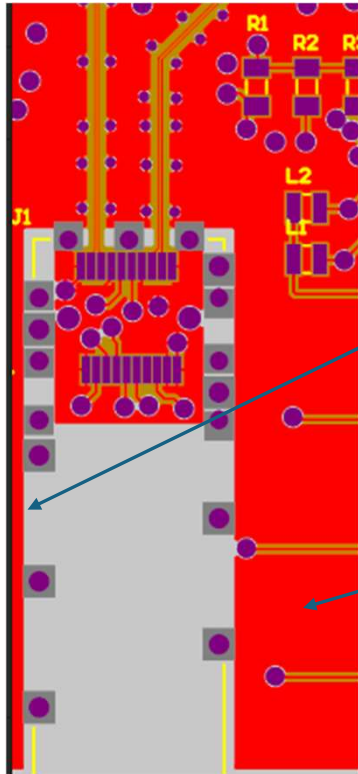
If room, add
one more
stich here

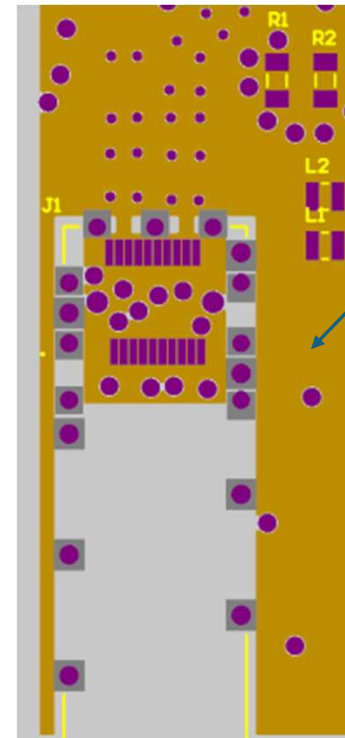
Clearance around hole

3.26mm hole
(4-40 clearance)

Delete metal here on layer 1 and 2 up to "J1"

Be sure all ground floods are tied to ground periodically

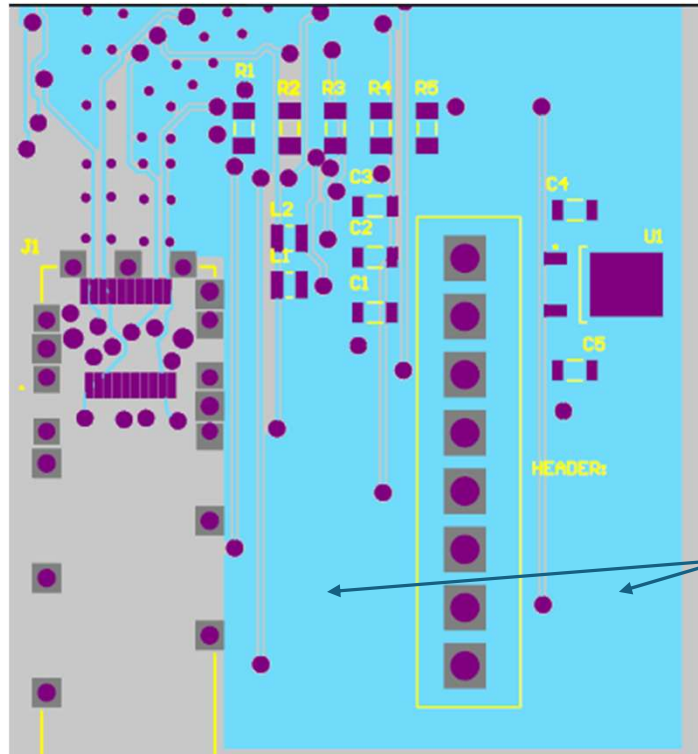
Be sure primary ground plane is unbroken

Be sure all ground
floods are tied to
ground periodically

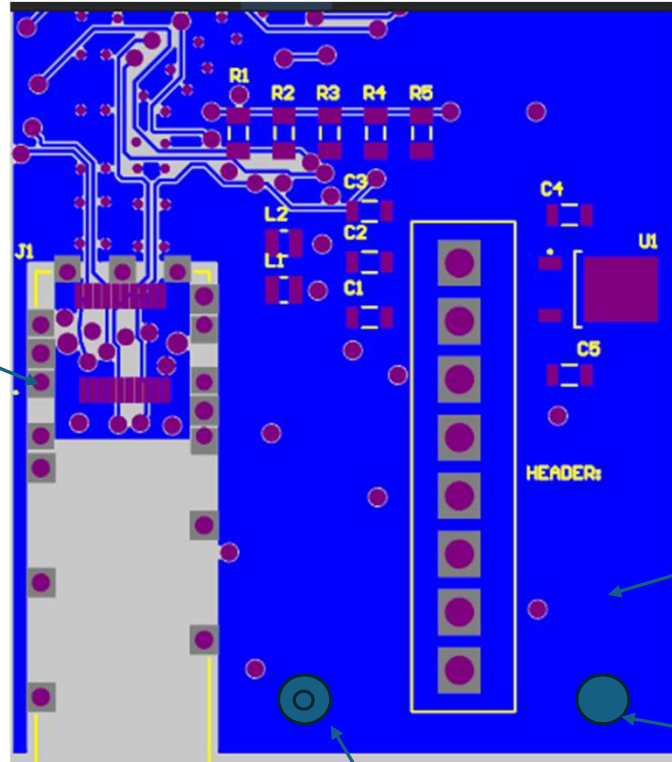
The cage should be tied
to chassis ground
Connect chassis
ground to PCB
mounting holes

Be sure this layer is
isolated (only chassis
ground)

Mounting holes should
be connected to
chassis ground

Opening is solder mask
